# **AMENDMENT REPORT**

## **Wellington North Solar Farm**

**March 2021**

**Project Number: 20-483**

Figure 2-1 Updated proposal layout.

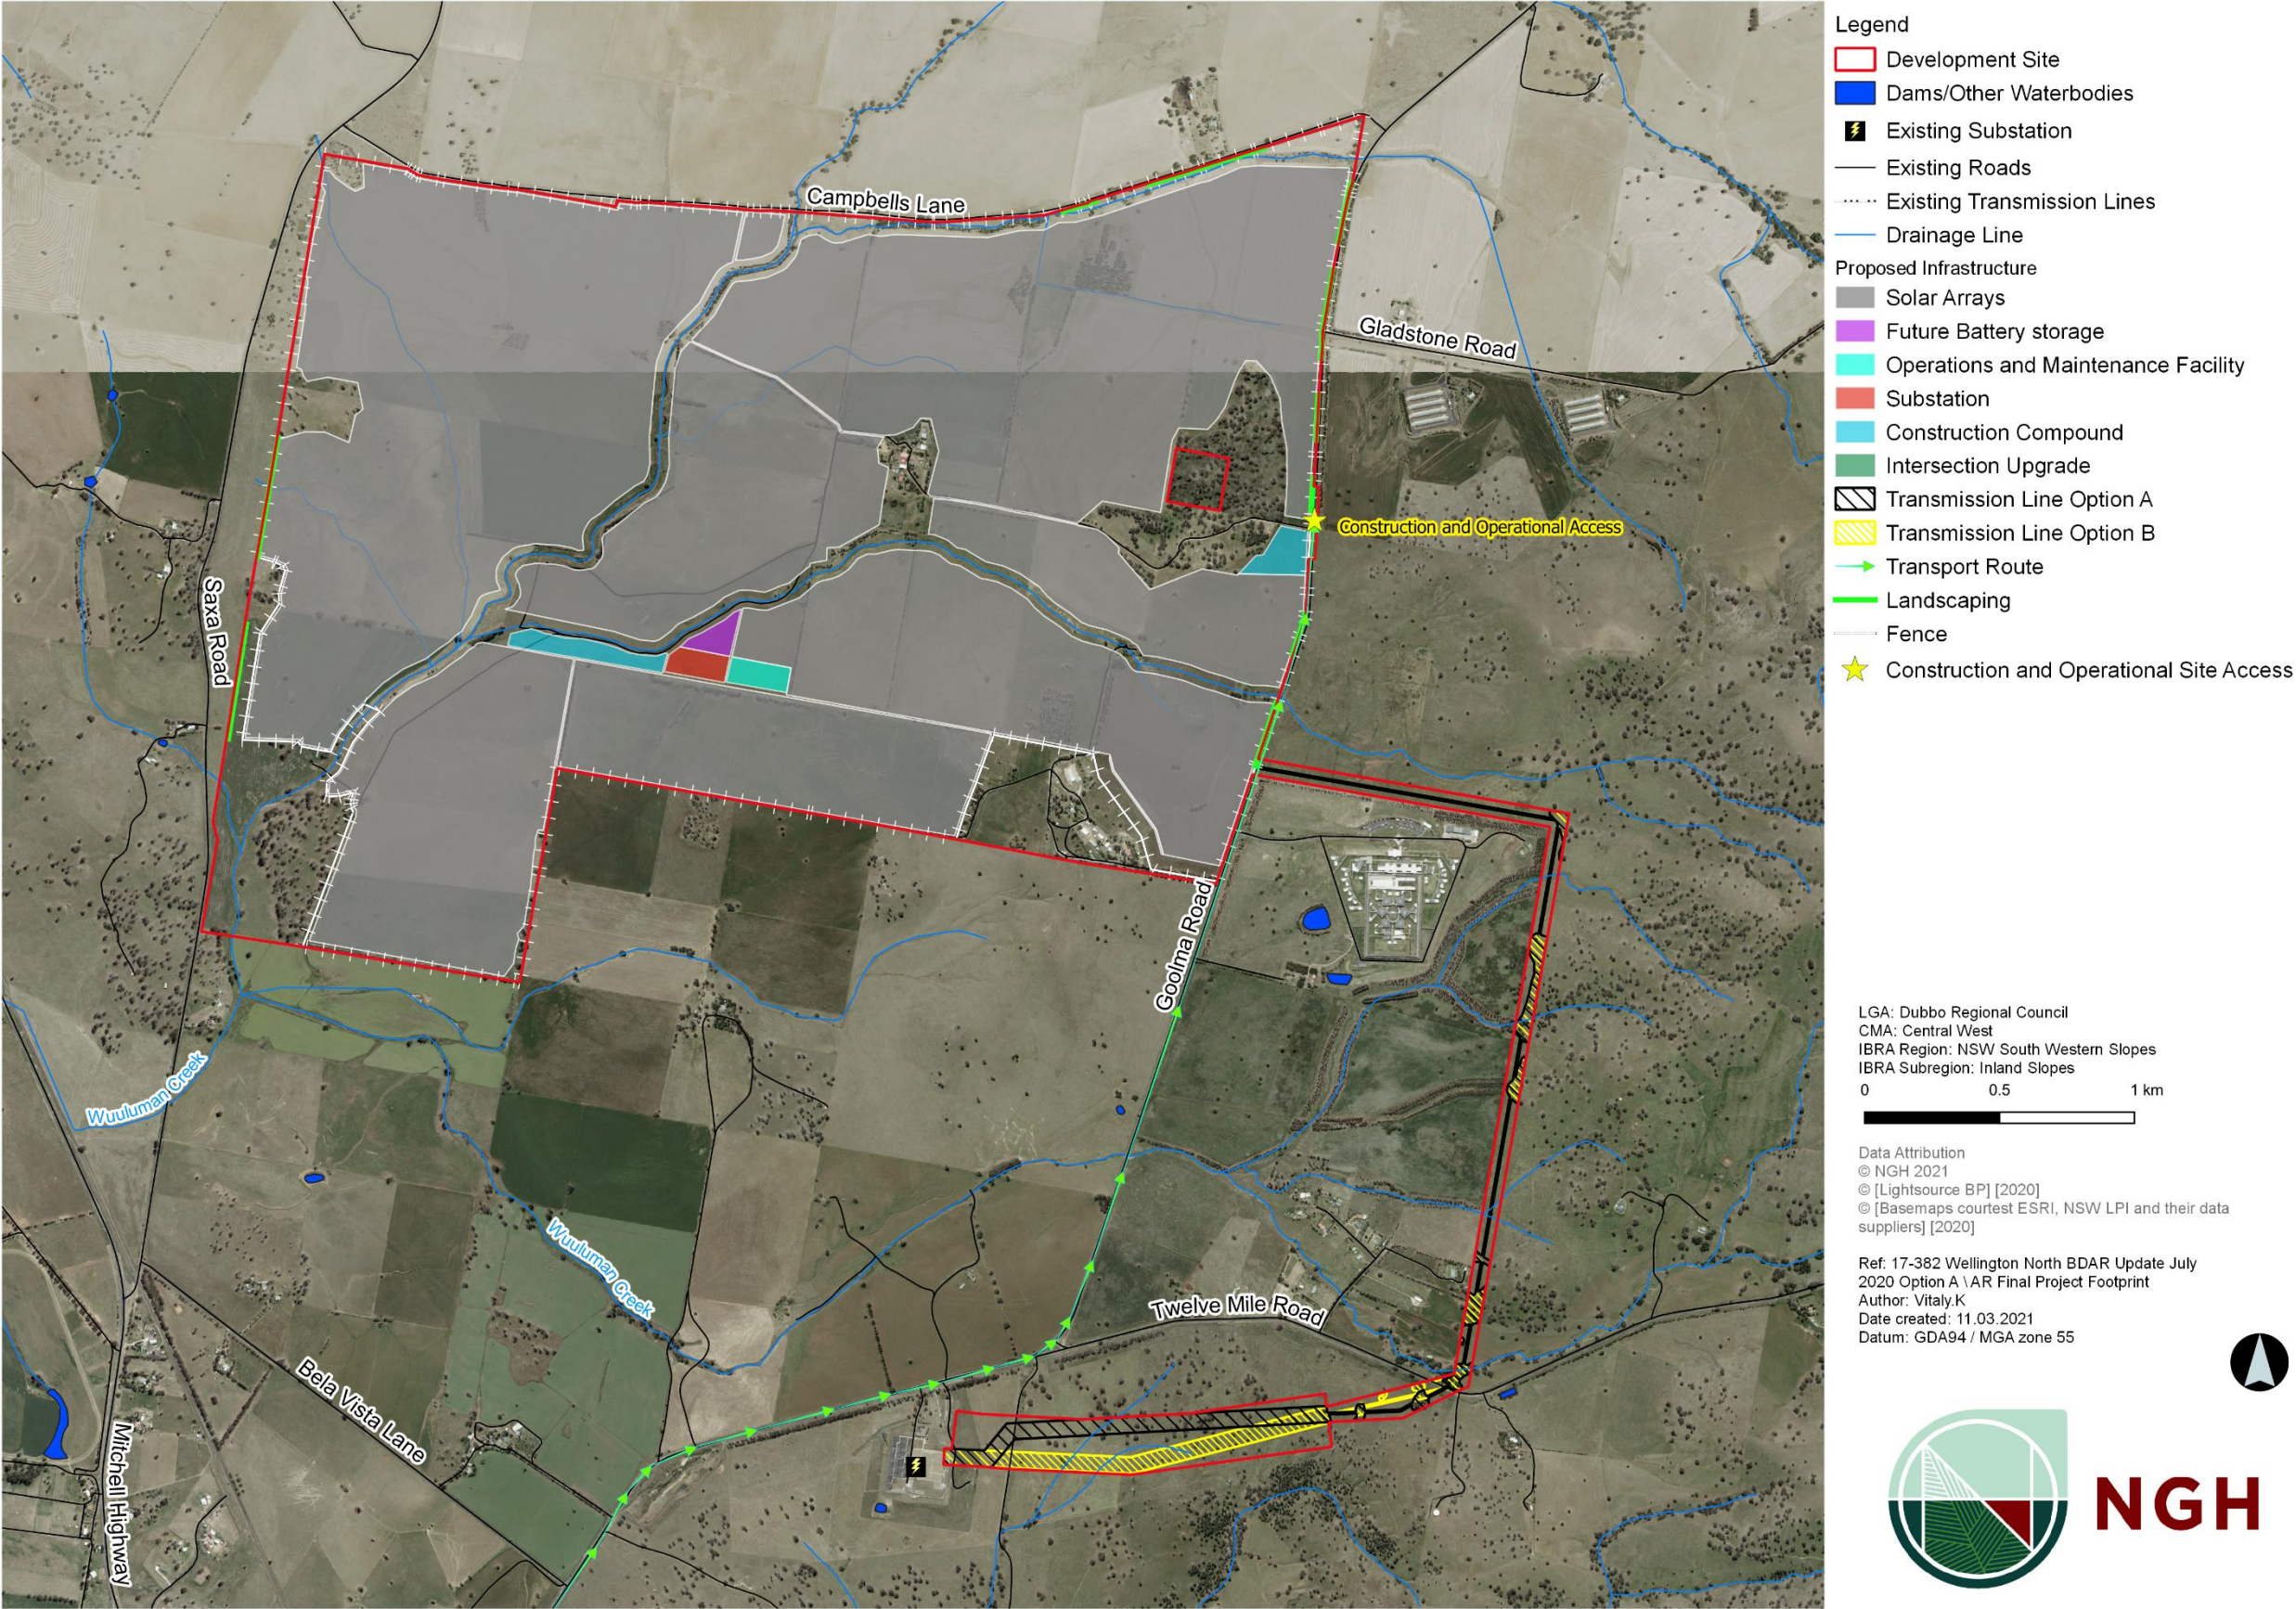
Two options for the development of the transmission line were described in the EIS, these were superseded by the 'new eastern transmission line' as described in the first Amendment Report (NGH, 2019). Lightsource bp has now proposed a change to this transmission line option. The justification for this is provided within Section 2.5 of this report. For this Amendment Report, the updated location for the transmission line relates to the southern portion of the transmission corridor, located within Lot 32 DP622471. The changes can be seen in the updated proposal layout and constraints map provided in Figure 2-1 and Figure 2-2. This portion is located between Twelve Mile Road and the Wellington Substation. The options for this portion include two overhead and/or underground routes for the 330kV transmission line (refer to Option A and Option B in Figure 2-1).

Near TransGrid's Wellington Substation the proposed new eastern transmission line may need to be located underground for a portion of the route, in order to avoid the relocation of existing transmission lines located within the proposed transmission line corridor (refer to Figure 2-1).

In the EIS there was a construction compound located near the construction site access point on Campbells Lane (Access Point 1). Given the proposed changes to the construction site access point, the Proponent now propose to relocate that construction compound to the entrance of the proposed new site access point on Goolma Road (Access Point 3). The updated location of this construction compound can be seen in the updated proposal layout and constraints map provided in Figure 2-1 and Figure 2-2.

Figure 2-3 Transport Route.

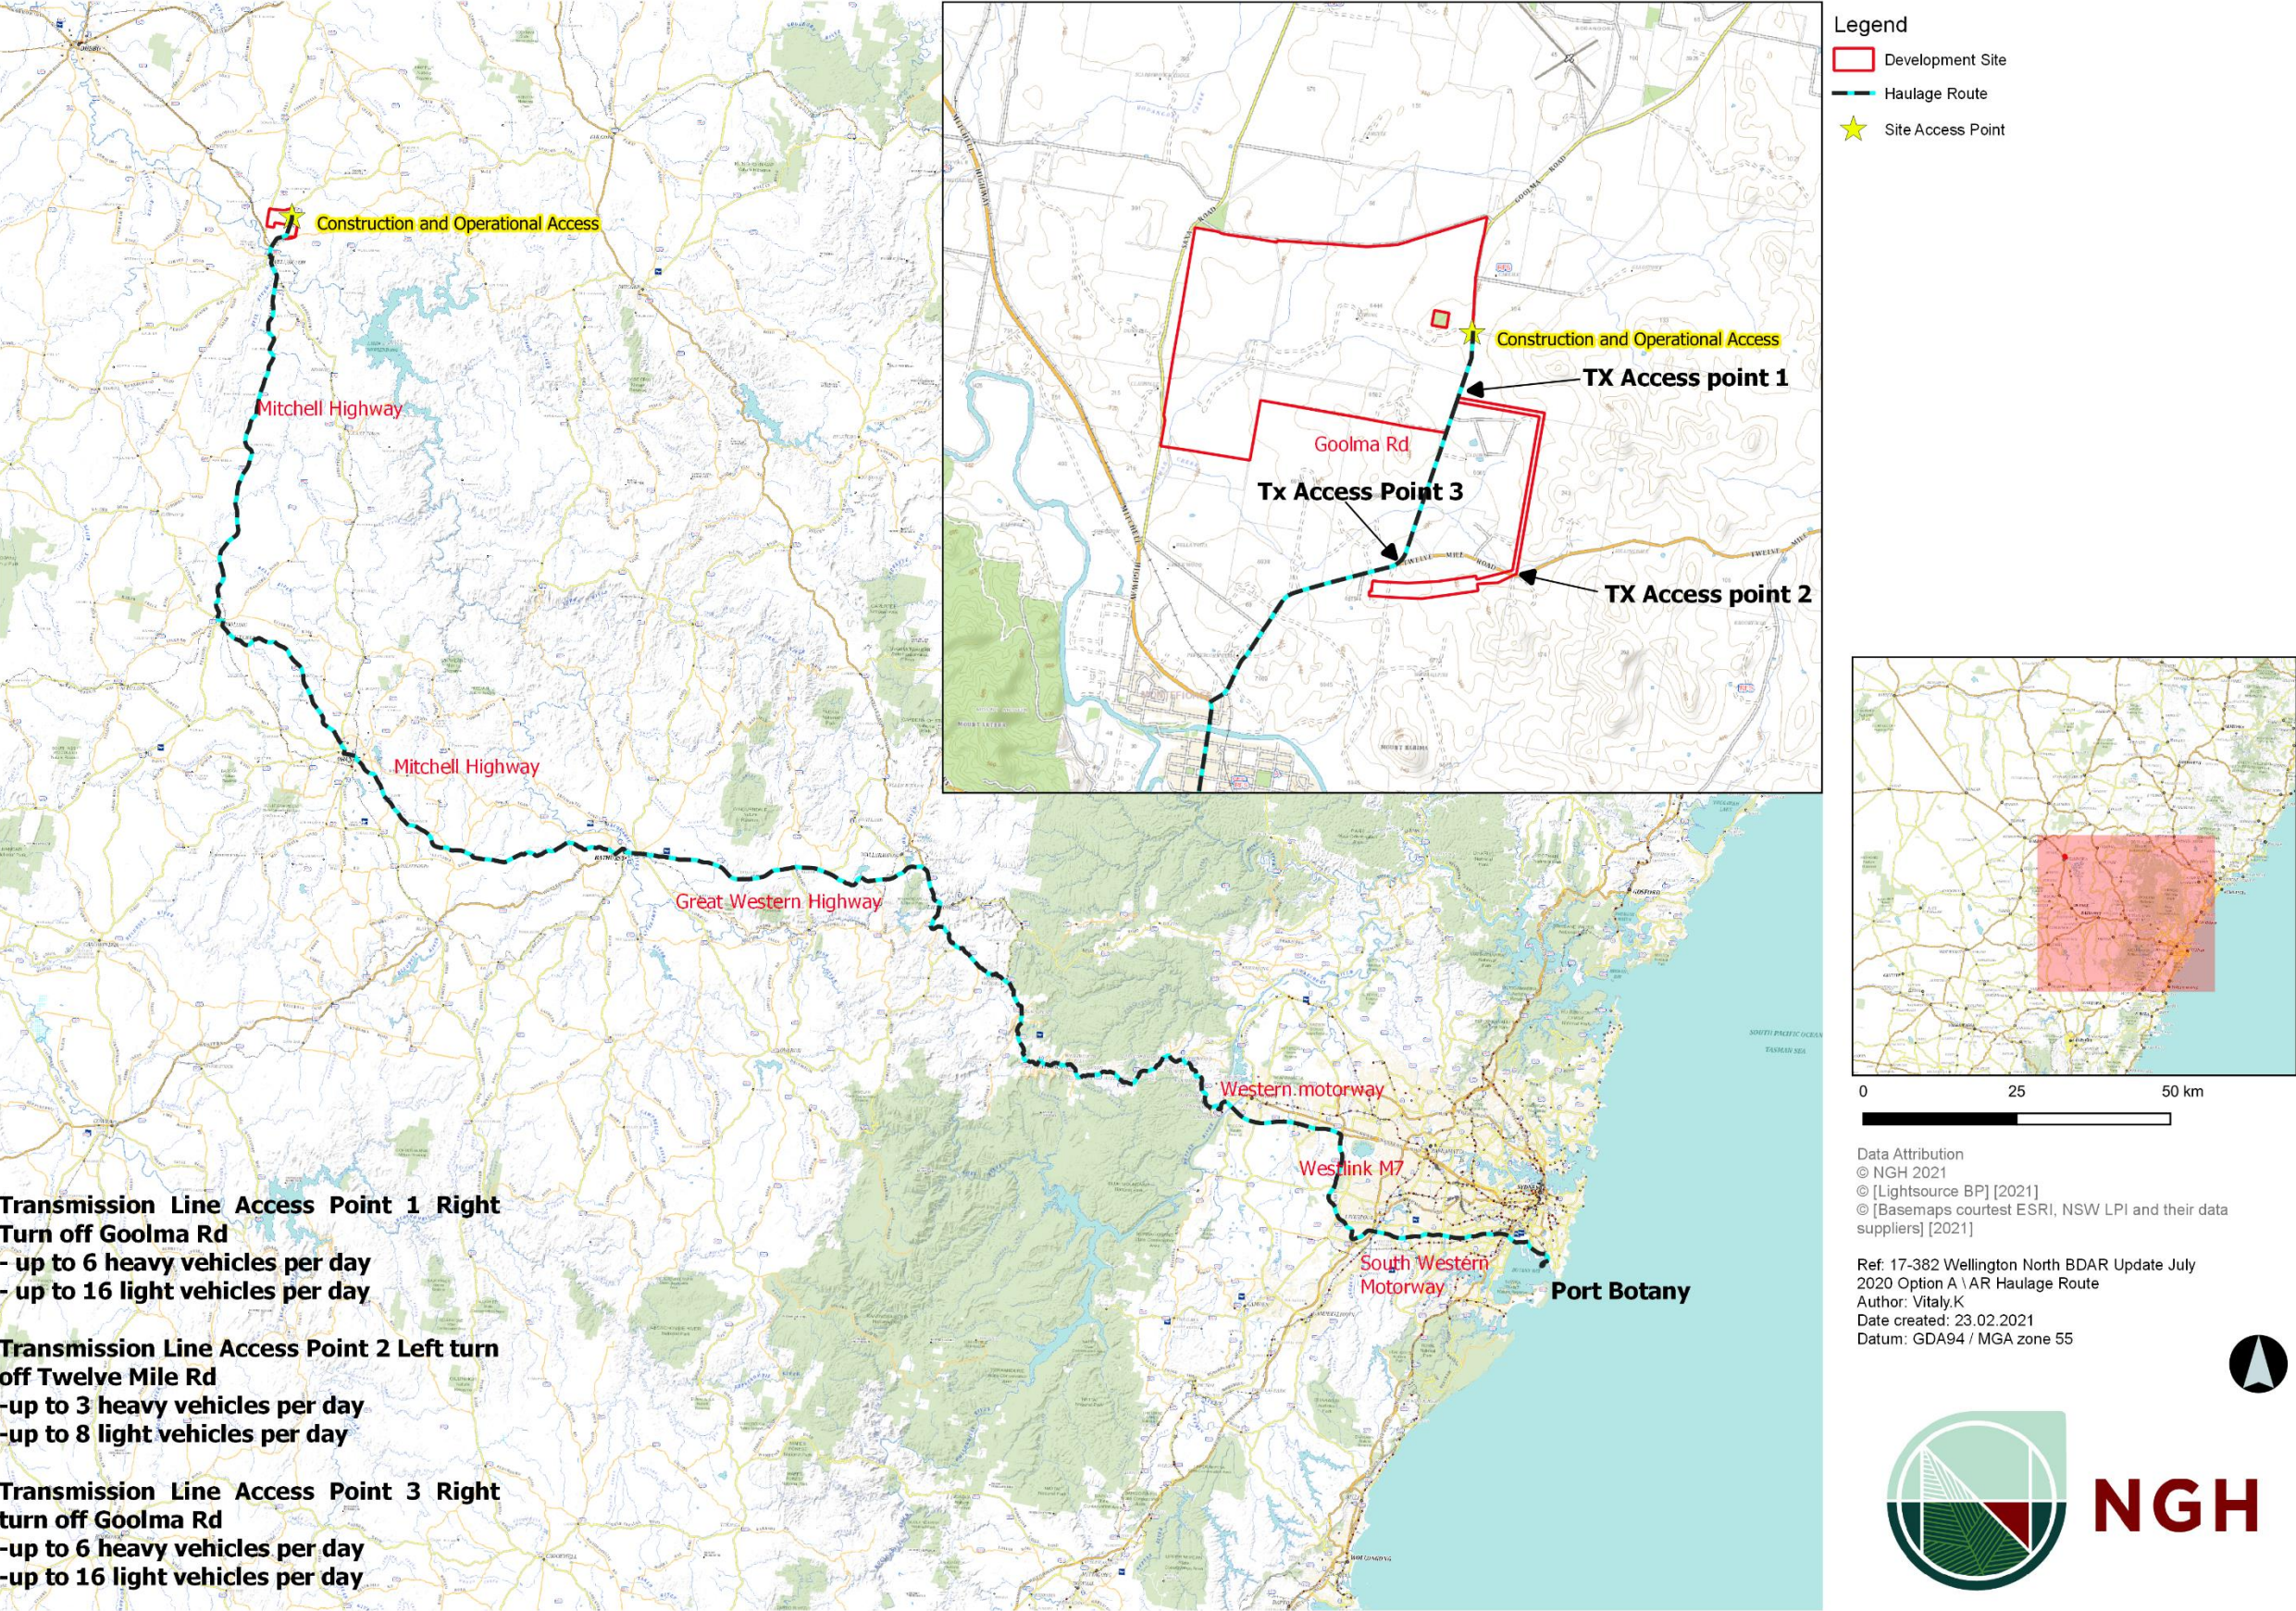
The EIS described the main vehicular access route to the Project site as being from Campbells Lane via Cobbora Road. Lightsource bp now proposes to access the Project site from the south via the Mitchell Highway and Goolma Road. Three site access options were described and assessed in the EIS and previous Amendment Report. The Proponent has now committed that all construction and operational site access would be via a single access point off Goolma Road. These changes can be seen in the updated proposal layout provided in Figure 2-1 and transport route map provided in Figure 2-3 and the justification for this is provided within Section 2.5 this report.

The EIS proposed the main transport route for construction materials would utilise Cobbora Road via the Golden Highway or the Mitchell Highway. Under this proposed amendment, all construction and operational access would be from the south via the Mitchell Highway and Goolma Road 40 metres north of the existing landowners driveway. The impacts of this change have been assessed in the updated *Traffic Impact Assessment* (GHD, 2021) and the Traffic Memorandum (GHD 2021). The updated Traffic Impact Assessment is summarised in Section 3.4 and provided in Appendix E. The Memorandum

Figure 3-14 AUL(S)/BAL turn treatments (GHD, 2020)

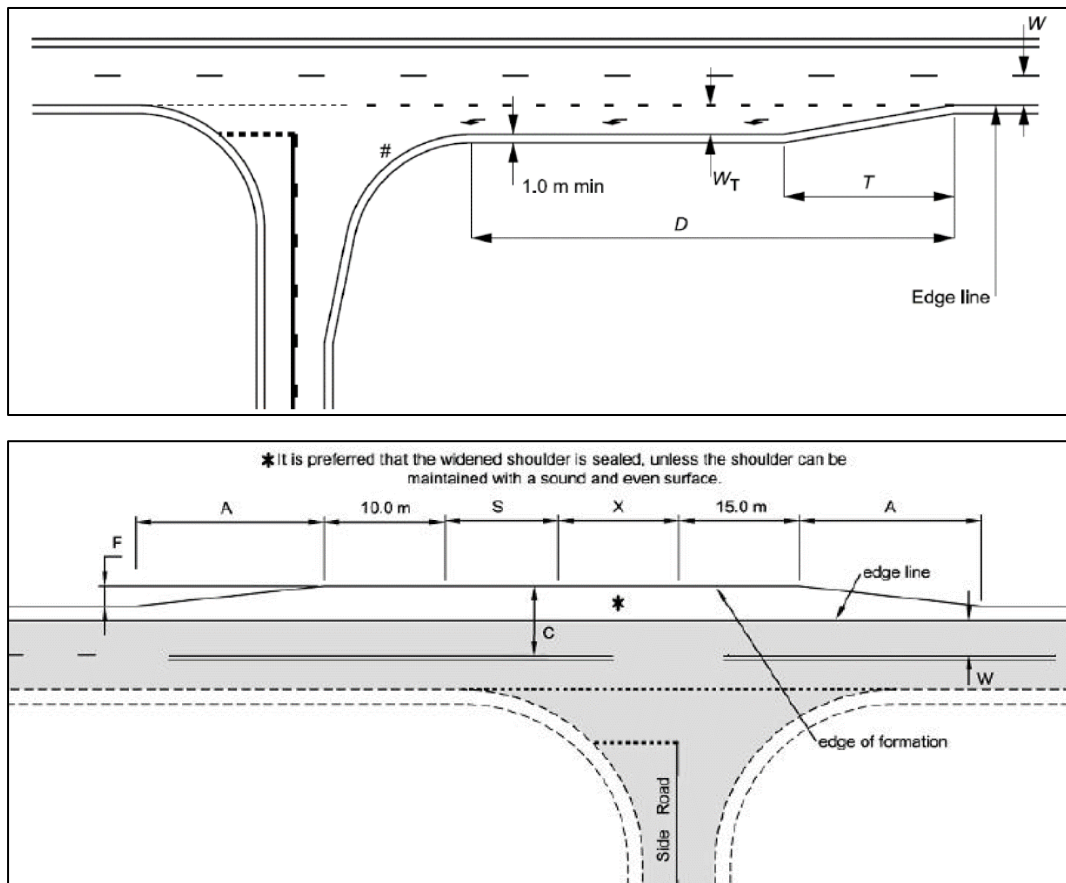
Based on the warrants, it is proposed that consideration could be given to the provision of a short auxiliary left turn lane (AUL(S)) from Goolma Road into the site (Figure 3-14). Although it is anticipated that all vehicles will be travelling to and from the south, incorporating shoulder widening on the eastern verge (i.e. BAR type treatment), would facilitate improved safety for southbound movement as well as facilitating the turn path of larger vehicles exiting the site, if required.

The treatments should be designed to accommodate articulated vehicles up to 19m in length (anticipated typical maximum vehicle length). Larger vehicles will require special permit and traffic management when required.

6	<p><b>The following intersections treatments must be undertaken prior to construction:</b></p> <ul style="list-style-type: none"> <li>• <b>The intersection of Goolma Road and site access be upgraded to provide a short Auxiliary Left turn lane AUL(S) northbound and a Basic Right turn lane (BAR) southbound.</b></li> </ul>	PC
